OXNARD SCHOOL DISTRICT

AGENDA
REGULAR BOARD MEETING
Wednesday, August 21, 2019

1 FIRST FLOOR - CLASSROOM BUILDING - MECHANICAL PLAN
1/8" = 1'-0"

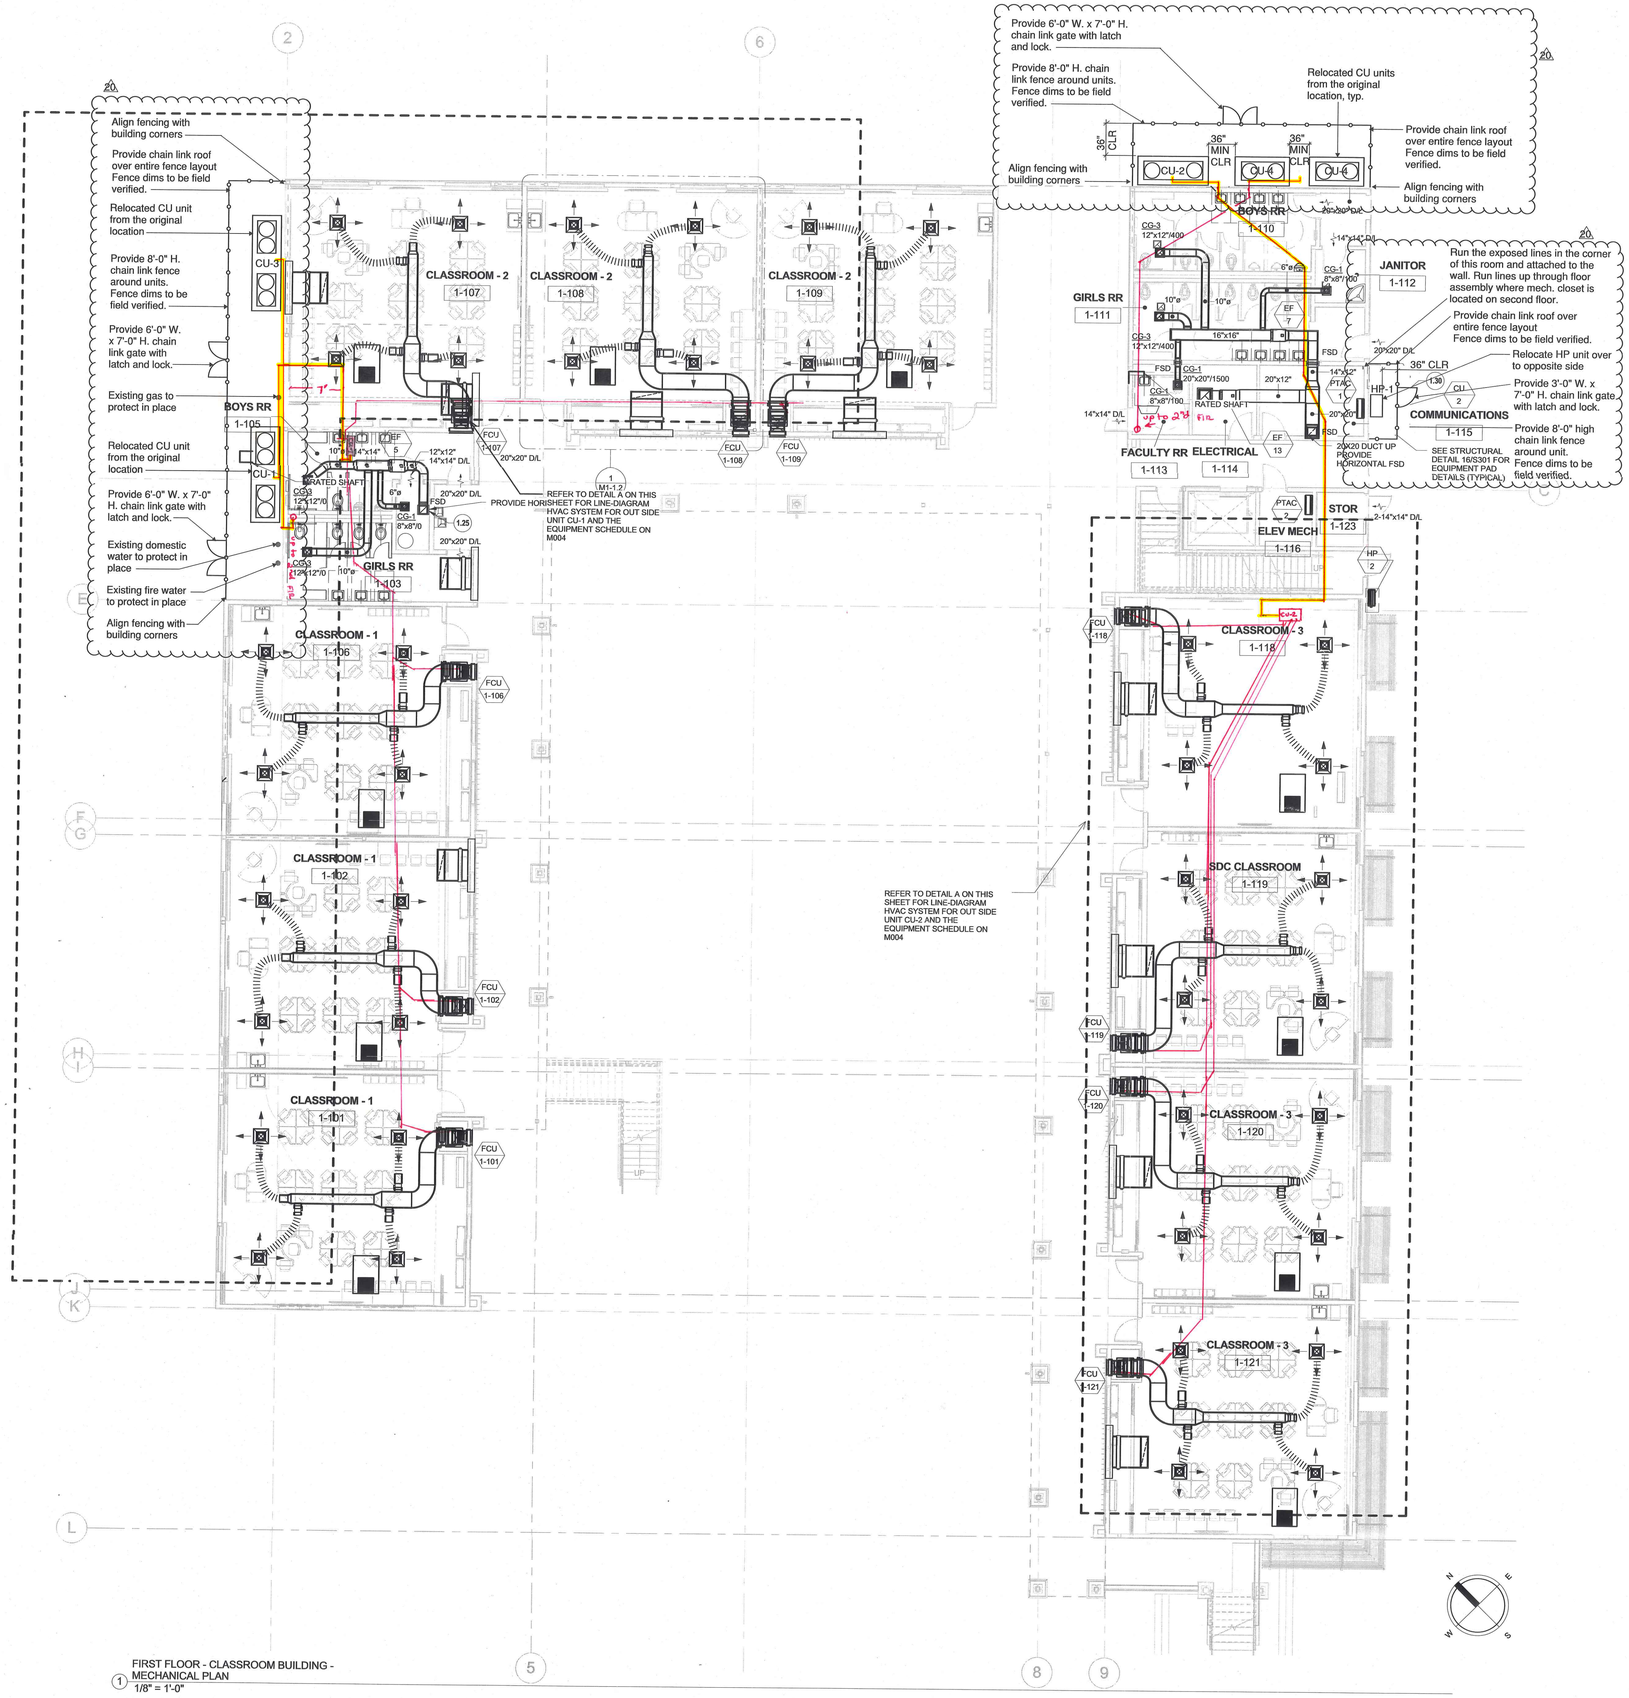
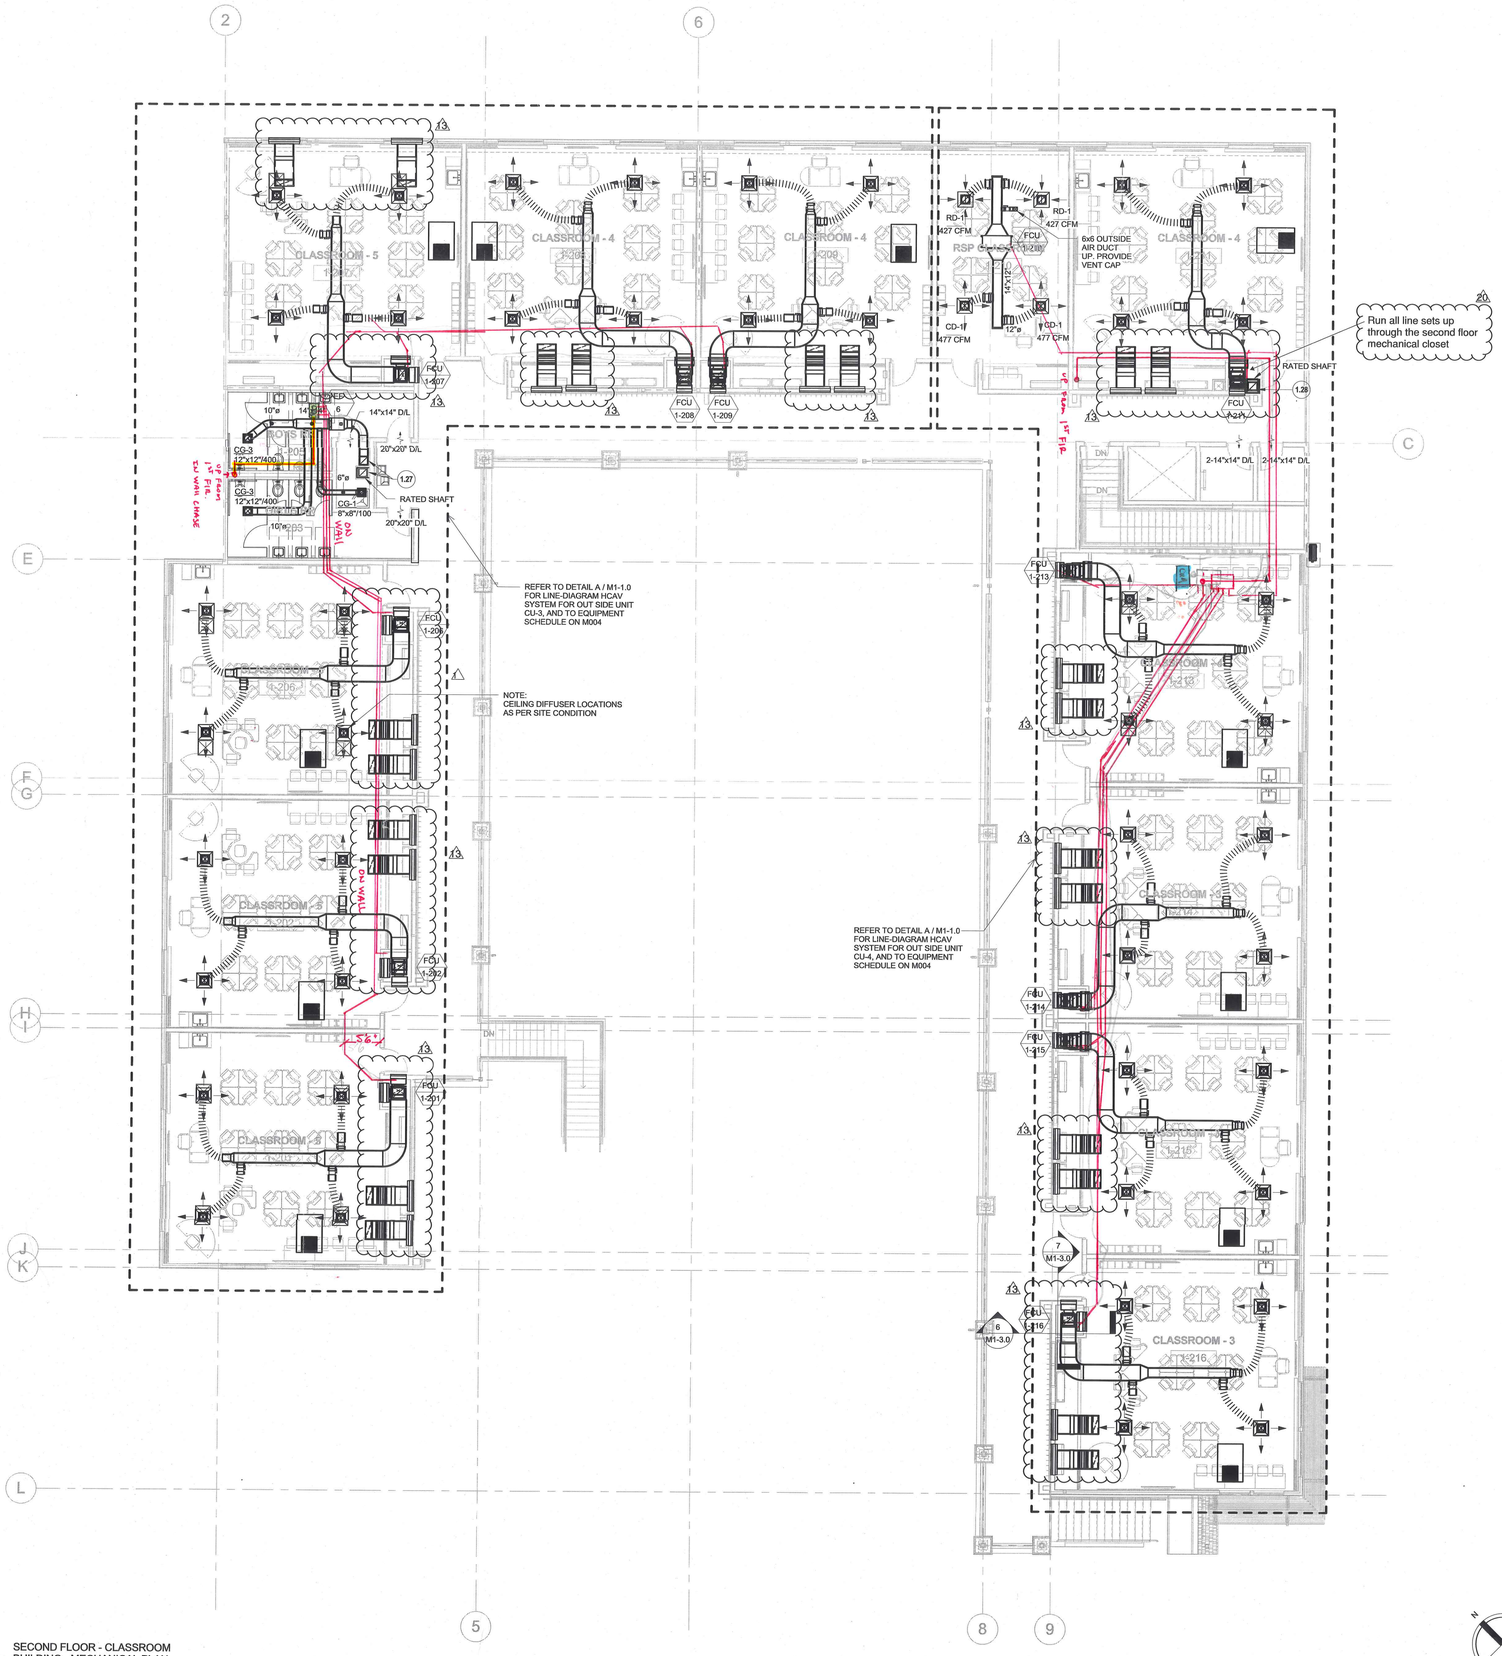
Changes to Drawings and/or Specifications:
Revisions to Architecture sheets:
A1-11.1: Room 1-115, run exposed lines in corner of room and attach to the wall.
A1-11.2: Added chase to classroom 1-206. For room 1-211, run all line sets from communication room (1-115) below into mechanical closet on second floor. (1-211)
A-61.2: Wall types for reference.
M1-1.1: Revised locations of the condensate units and heat pump to be closer to the interior chase walls.
M1-2.0: Shown location of routed lines in mechanical closet in room 1-211.

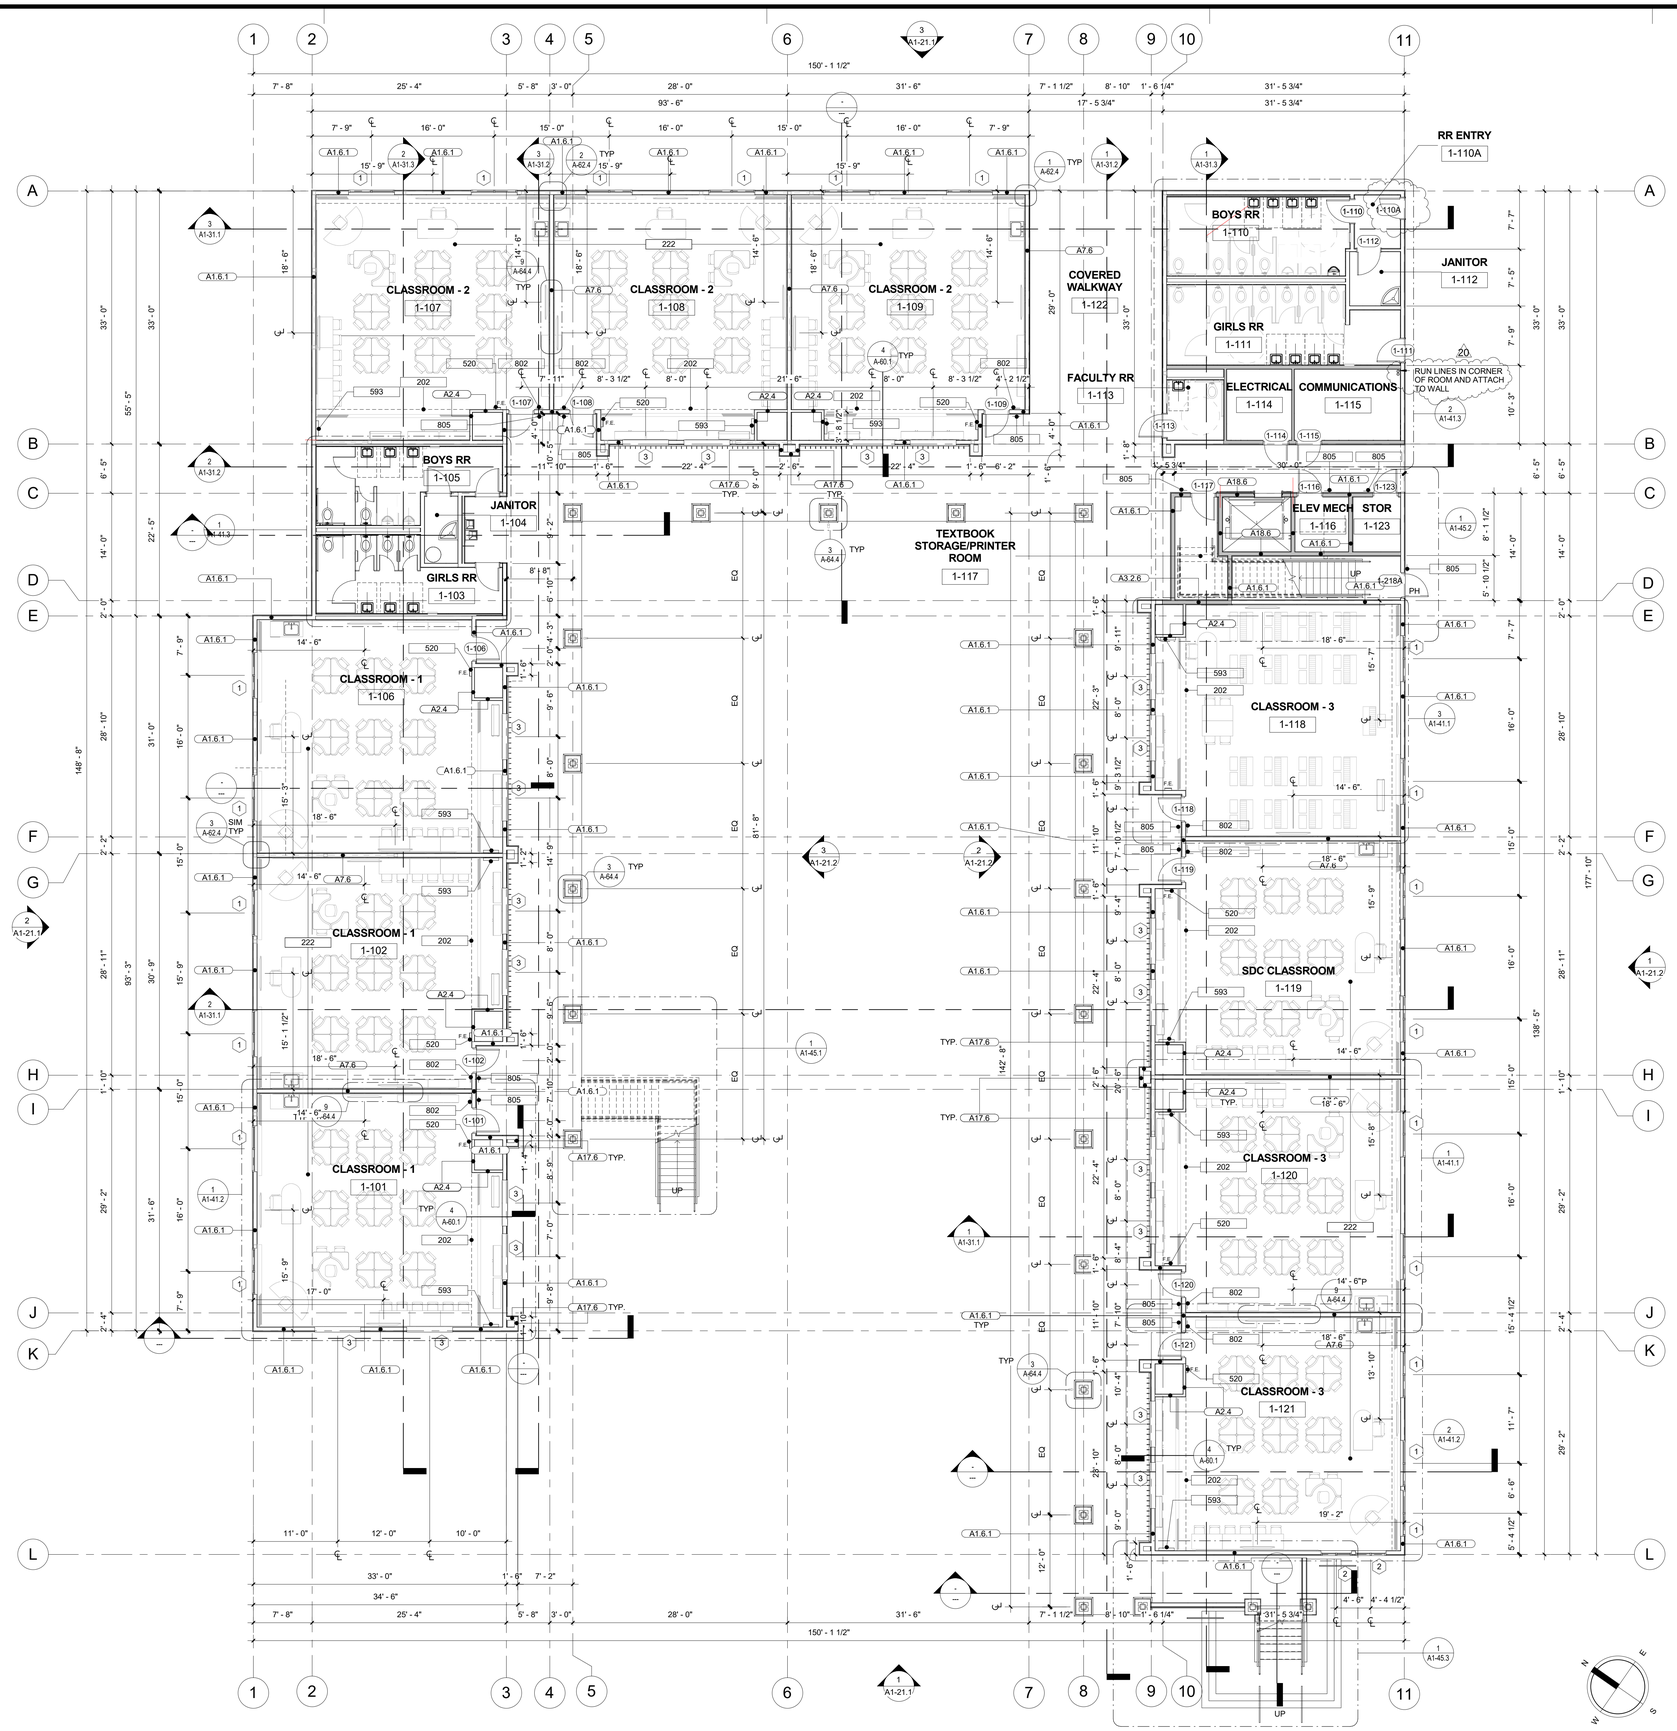
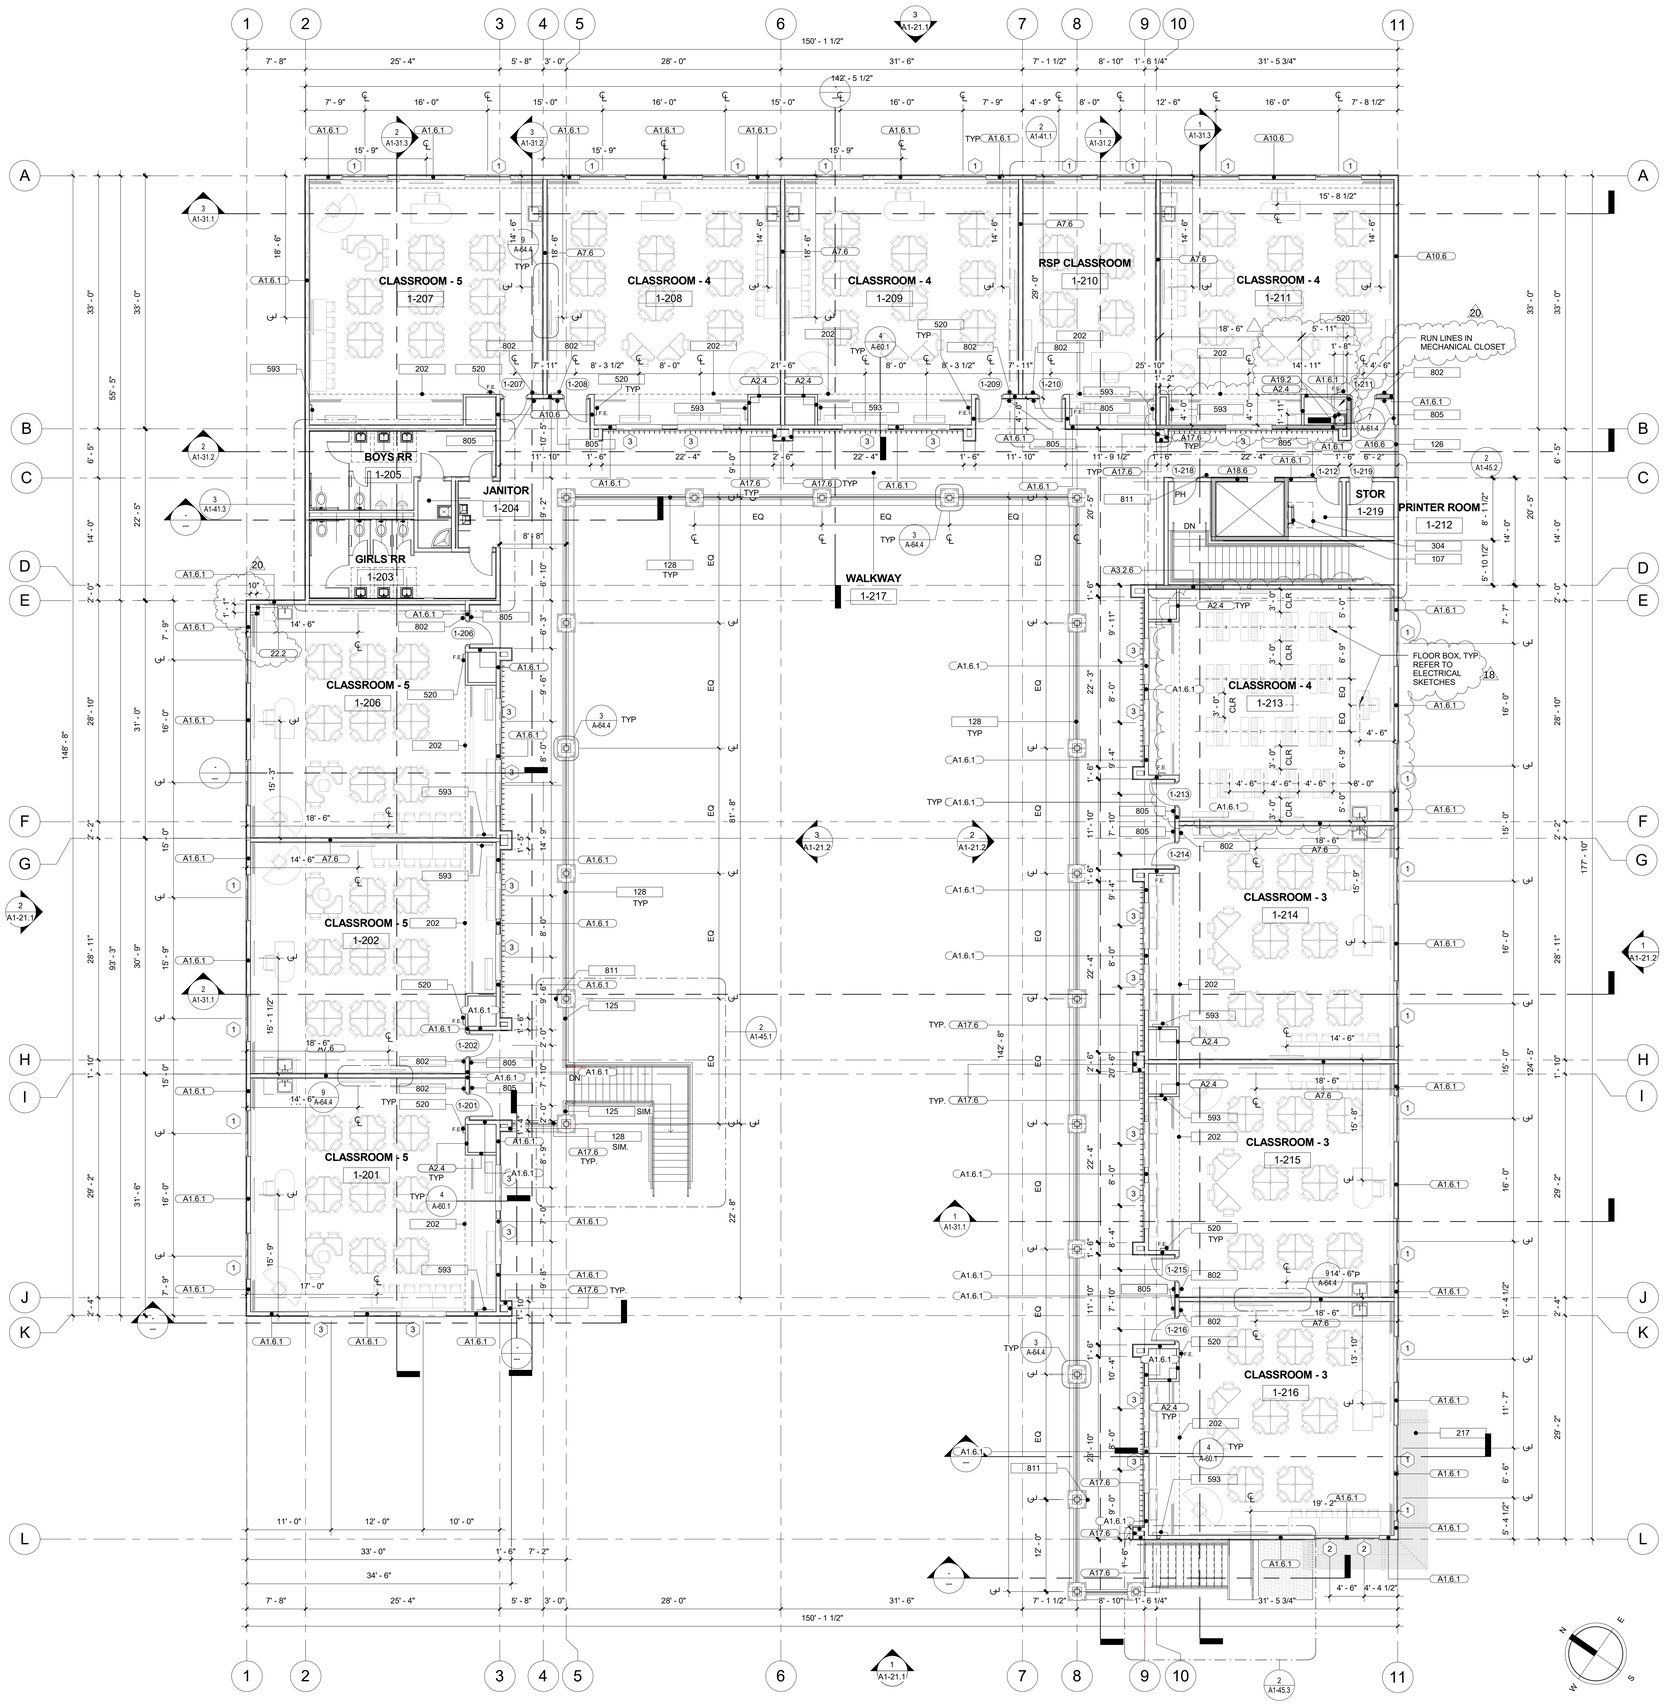
Changes to Drawings and/or Specifications:
Revisions to Architecture sheets:
A1-11.1: Room 1-115, run exposed lines in corner of room and attach to the wall.
A1-11.2: Added chase to classroom 1-206. For room 1-211, run all line sets from communication room (1-115) below into mechanical closet on second floor. (1-211)
A-61.2: Wall types for reference.
M1-1.1: Revised locations of the condensate units and heat pump to be closer to the interior chase walls.
M1-2.0: Shown location of routed lines in mechanical closet in room 1-211.
